4. Speed Warning System

229LC148

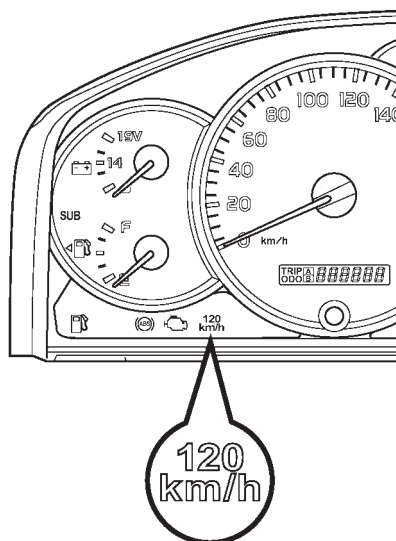
On the previous model for the G.C.C. countries, the buzzer of the speed warning system continues to sound at speeds of 120 km/h or higher. This has been changed to a system that sounds the buzzer in the combination meter for a prescribed duration (6 seconds) and then blinks the speed warning light in the combination meter.
